Planning Commission Staff Report

Subject: Rezoning Issues Report

Petition: P.Z. 28-2007 THF Chesterfield Seven Development (THF Chesterfield Seven Development LLC)

REZONING PLAN & CROSS SECTION PROFILES

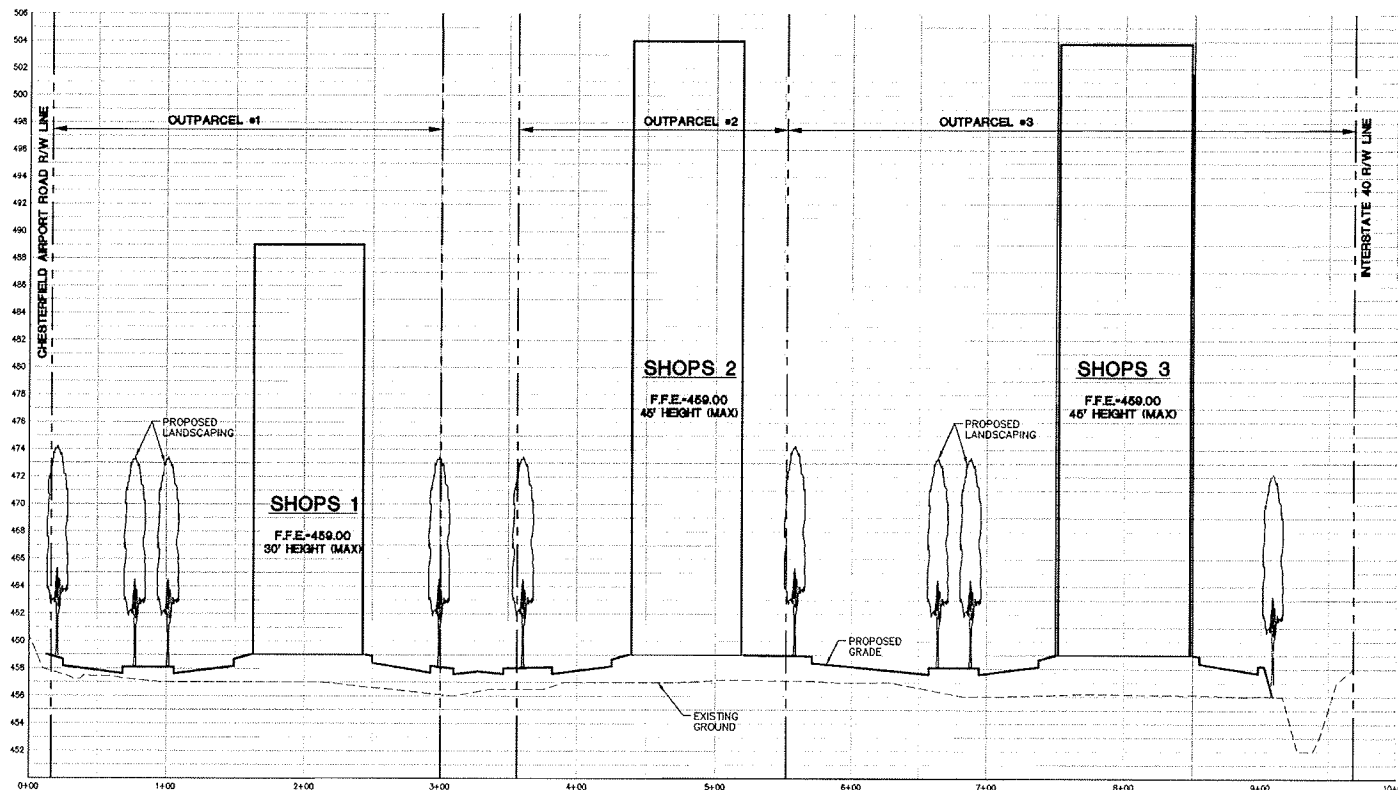
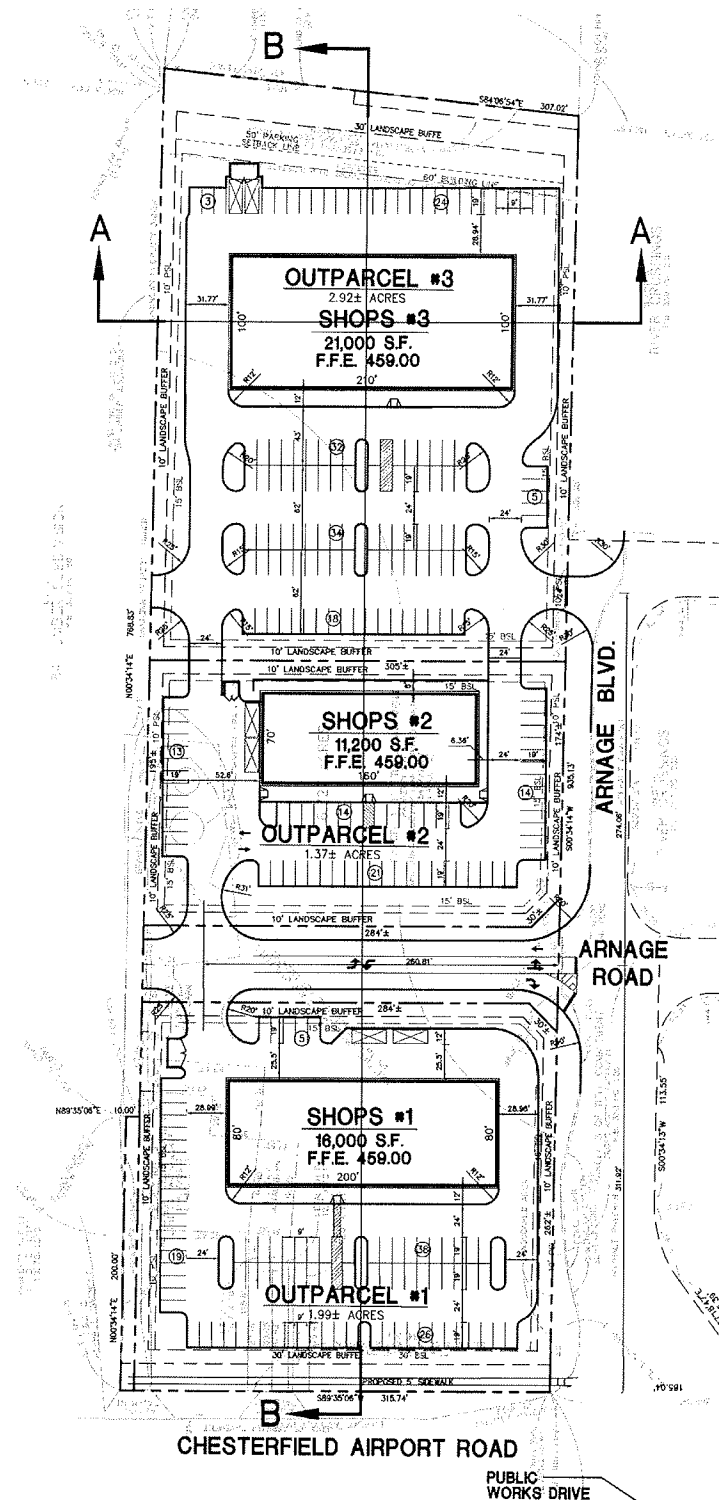
- Please be advised that cross access will be required to be provided to 17505 Chesterfield Airport road which is located to the west of this site. The revised plan does not show that cross access can be provided.

Petitioner's response: Petitioner understands from conversations with staff that this requirement has been deleted.
